Dharma Cloud Foundation

September 4, 2006

App. 1-06-022-A1
September 7, 2007 ;
Item 10a. Ten Mile Bridge
Railing

TEN MILE RIVER BRIDGE

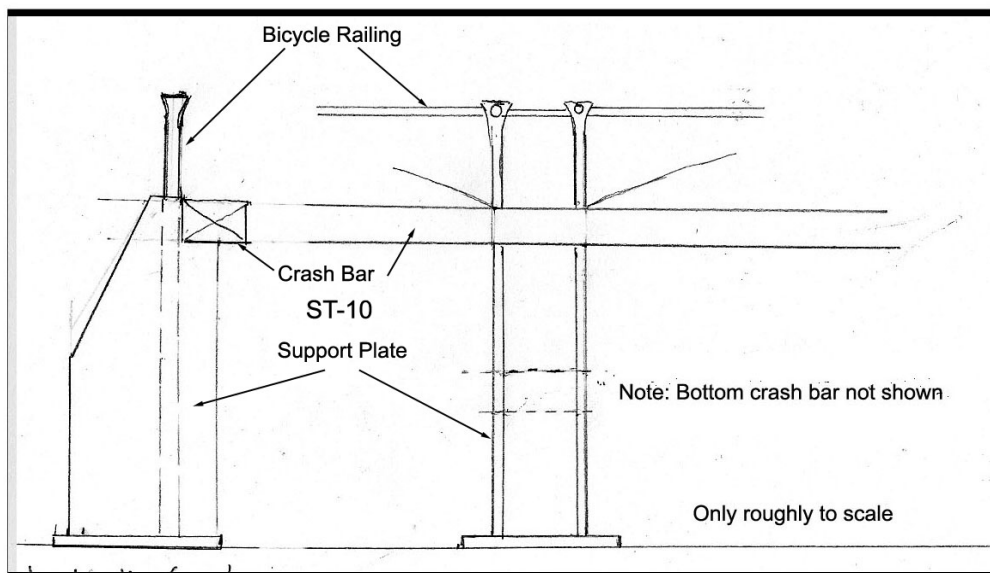
The Caltrans design for the combination automobile/bicycle railing creates a significant hazard for cyclists. An entirely separate bicycle railing is placed at the **back** of the supporting plates for the automobile barrier (the ST-10). In consequence the bicycle railing is 15" behind the front of the ST-10 crash bar, and there is a horizontal gap of about 7 inches between the back of the crash bar and the bicycle railing.

The gap is unnoticeable in the photo simulations provided to the Commission in Exhibit 1 of the amendment application. However, the gap shows clearly in the cross section of the railing in Exhibit 2

of the amendment (reproduced here). I myself was unaware of the significant setback of the bicycle railing until I saw the permit application and its Exhibit 2.

A cyclist who went over the lower, 32-inch high automobile barrier could easily have an arm, shoulder, leg, knee, or shoe go into the gap between the automobile crash bar and the bicycle rail. If he or she had the misfortune of then colliding with one of the sharply angled support plates of the ST-10, a serious injury could well occur.

The bicycle railing is 15" behind the front of the ST-10 crash bar, which will look peculiar to motorists and, especially, cyclists. Both will see the gap between the back of the ST-10 and the bicycle barrier. Because of its placement, the bicycle rail will look like an add-on rather than an integrated part of the overall rail design. This defeats one of the design goals for the railing system.

Placing the bicycle railing behind the ST-10 support plates also creates another problem. The pedestrian and bicycle railings have graceful, fairly wide twin support posts. These are quite elegant on their own, but placing them behind the ST-10 support plates brings them into conflict with the design of the ST-10.

One of the aesthetic strengths of the ST-10 is the use of the paired "thin" vertical supports instead of thick "posts." The posts of the bicycle rail are thick rather than thin. When placed behind the ST-10, these posts essentially fill the opening between the paired thin supports of the ST-1

The obvious solution to all of the problems with the present design is to integrate the bicycle railing into the ST-10. This could be done by joining the bottom bar of the bicycle railing to the back of the top crash bar of the ST-10 and modifying the railing posts so that they don't fill the space between the two support plates. A rough sketch of this concept is below.

With the alternative design, there would no longer be a gap, nor would the bicycle support posts fill up the space between the support plates of the ST-10.
